**DRAFT STATE ENVIRONMENTAL PLANNING POLICY (PRECINCTS  
WESTERN PARKLAND CITY) AMENDMENT (PENRITH LAKES SCHEME) 2023**

**RE: PENRITH LAKES TRAFFIC AND TRANSPORT INVESTIGATION  
TRAFFIC MODELLING REPORT**

## Attachment A: Key Comments on the Penrith Lakes Traffic and Transport Investigation – Traffic Modelling Report (dated 10 January 2022)

**Figure 1: Scenario C – Future Road Network and 100% Development in 2036**

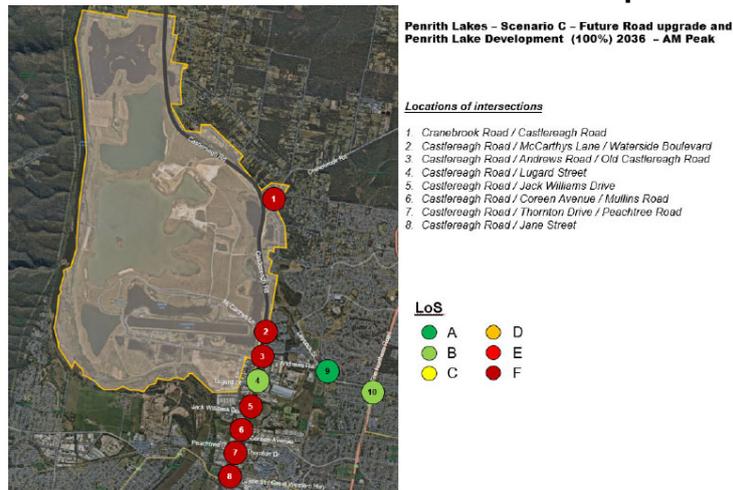
The 65% and 100% scenarios are not supported as significant road works well beyond the major transport infrastructure projects (Refer Figure 14, Section 4.1 of the final report) being planned, committed (subject to funding) would be required to support this level of traffic. Intersection and mid-block upgrades beyond the TfNSW planned upgrades (committed, subject to funding) are required to support 100% of development traffic given that seven (7) intersections modelled fail on Castlereagh Road in the 2036 AM peak even with TfNSW planned upgrades (committed, subject to funding) as shown in Figure 1. Any further upgrades beyond the future planned, committed (subject to funding) major transport projects would likely be unfeasible due to the extent of third-party land components required and costs associated with land acquisition. This means 100% of development traffic is beyond the capacity of Castlereagh Road even with planned, committed (subject to funding) major transport infrastructure upgrades and this level of development (100%) should not be pursued as this would likely result in significant travel time delays to regional traffic and the broader community.

**Figure 2: Scenario A – Existing Road Network and 20% Development in 2026**

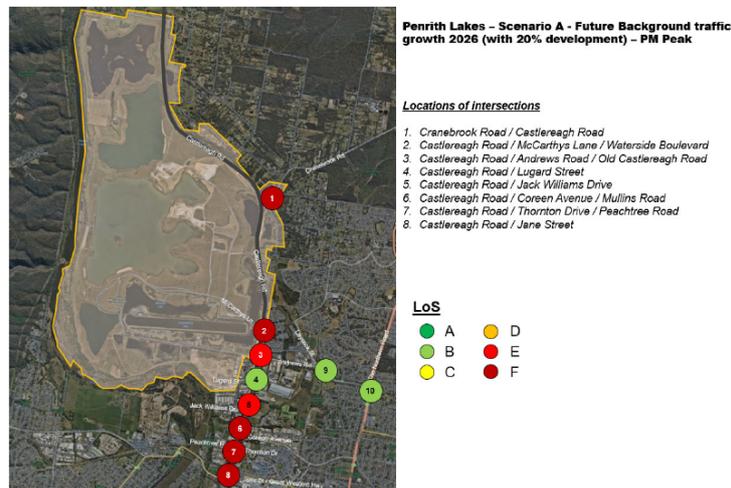
To support 20% of the development yield on the existing road network, the developer must provide Works in Kind to satisfactorily upgrade five (5) intersections (No. 1, 3, 5, 7 & 8) and provide contributions and/or Works in Kind to satisfactorily upgrade further two (2) intersections (No. 2 & 6) on Castlereagh Road as shown in Figure 2.

On this basis, the developer should be responsible for delivering satisfactory upgrades to intersections (No. 1, 3, 5, 7 & 8) as Works in Kind in order to unlock 20% development, while an apportionment formula should be used to calculate their contributions towards an upgrade of the other two (2) intersections (No. 2 & 6). However, as McCarthys Lane/Castlereagh Road intersection (No. 2) forms a key access point to the site, and 20% development traffic will bring forward the need for upgrades to this intersection, the developer will also need to provide Works in Kind at this intersection to unlock the 20%

**Figure 3: Scenario C – Future Road Network and 20% Development in 2026**

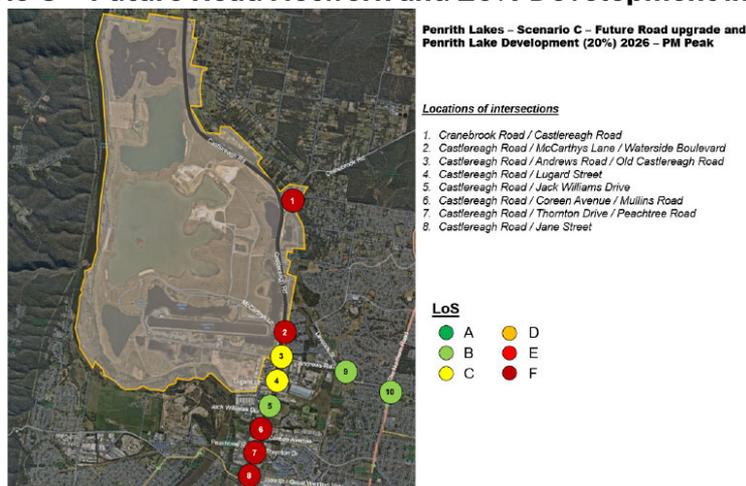
A modelling scenario with 20% development traffic and TfNSW’s planned, committed upgrades (subject to funding) indicates that five (5) intersections (No. 1, 2, 6, 7, 8) on Castlereagh Road require *further* upgrade to support 20% development as per Figure 3. This shows there is a nexus between the development traffic (20%) and the majority of the intersection upgrades required on Castlereagh Road, and that the developer would need to provide upgrades to support this level of development with or without the TfNSW planned, committed upgrades (subject to funding).
